**SUNDRY NOTICES AND REPORTS ON WELLS**  
*Do not use this form for proposals to drill or to re-enter an abandoned well. Use form 3160-3 (APD) for such proposals.*

Apache request to change CSG/CMT/BOP program as follows:  
IN THE EVENT CMT IS CIRC TO SURF ON PRIMARY CMT JOB FOR SURF CSG:

AAO Federal #30

## CONDITIONS OF APPROVAL

Eddy County, New Mexico  
Sec 1, T18S, R27E  
AAO Federal #30  
Quote 140599  
Design #3

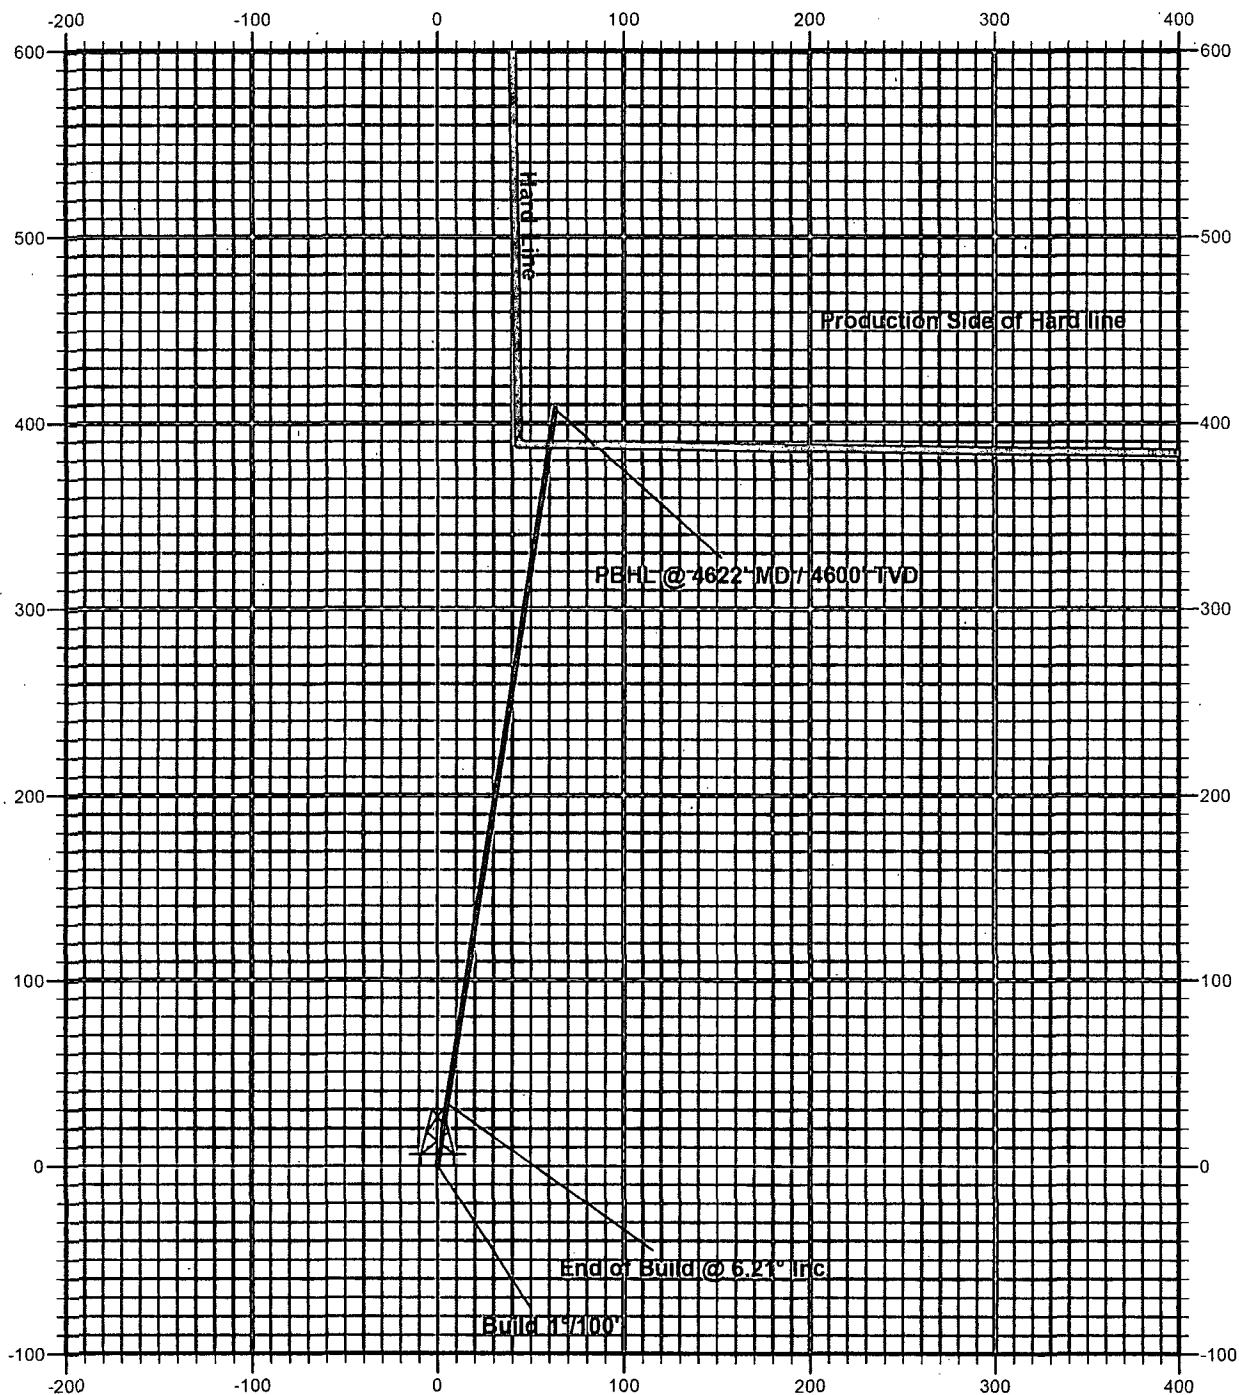
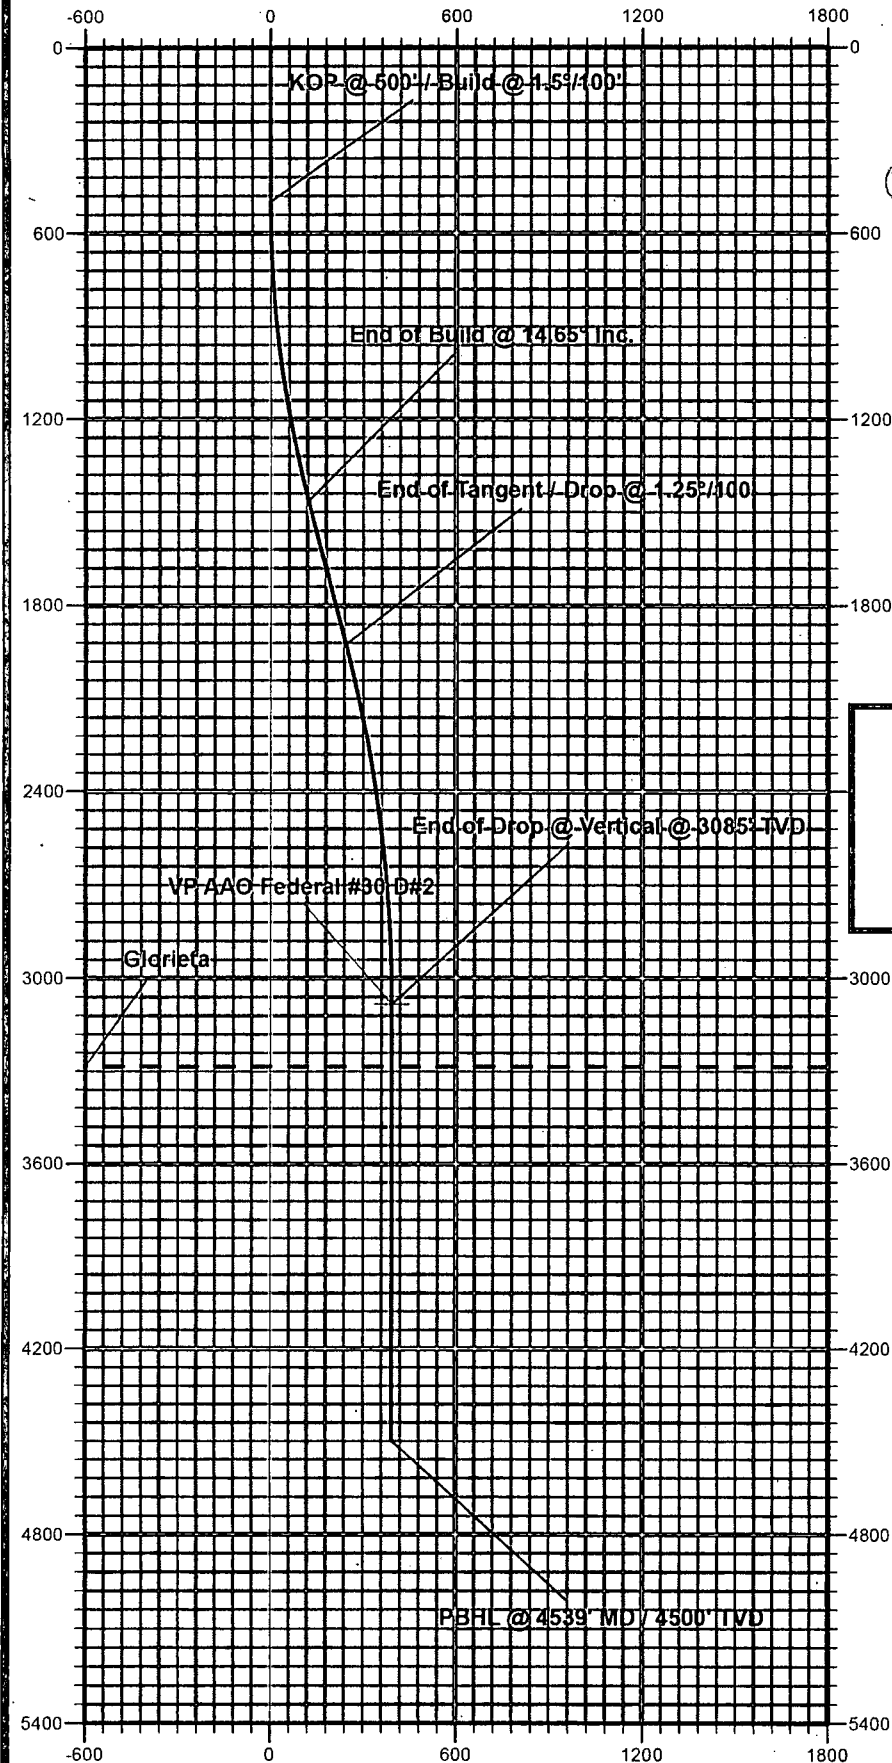
**\*\*\*Rest of CMT PROGRAM & PROPOSED CONTROL EQUIP on attachment due to lack of space. Have also added a new directional plan.\*\*\***
